### U.I.P., REDECK AND MAKE COMPOSITE EXISTING (43'-66'-66'-43') CONTINUOUS I-BEAM SPANS

#### REPAIRS TO BRIDGE OVER ROUTE 36

STATE ROAD FROM HAMILTON SOUTH  
 ABOUT 0.5 MILE S. OF HAMILTON  
 STA. 30+97.03± (Match Existing)

FINAL PLANS

TYPICAL SECTION NEAR SPLICE GAP  
\* At about 30'-0" centers with at least one splice gap between pull posts.

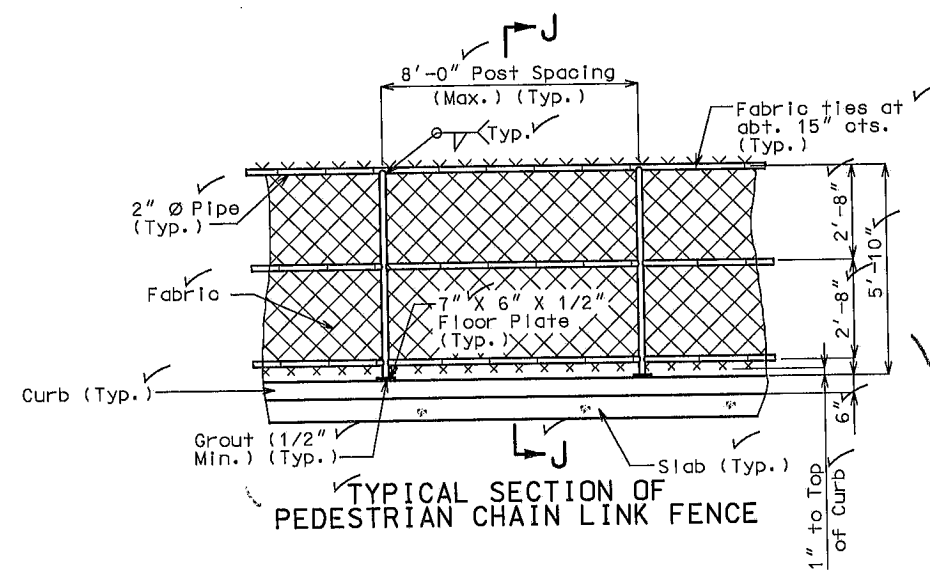
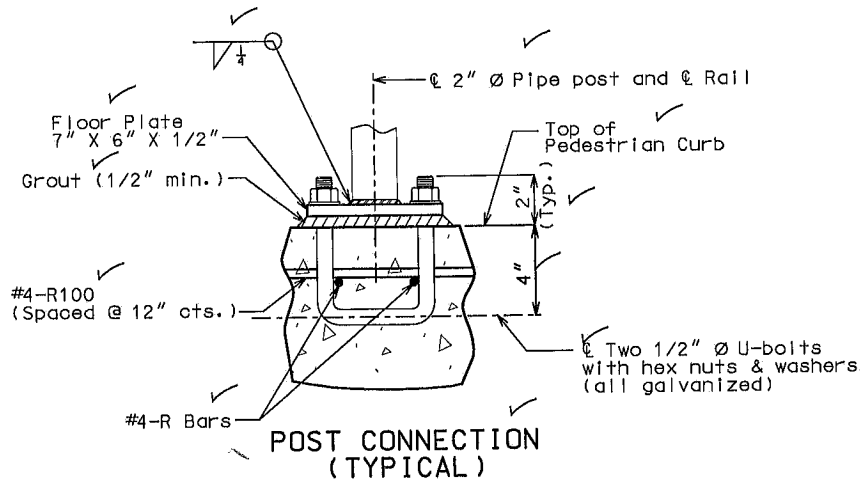
NOTE:  
1/2" X 6" X 15" GALVINIZED PLATE ADDED TO FENCE POST AT BENT 5 BOTH LT & RT. THIS CORRECTED BOLT MISPLACEMENT FOR POST SUPPORT.
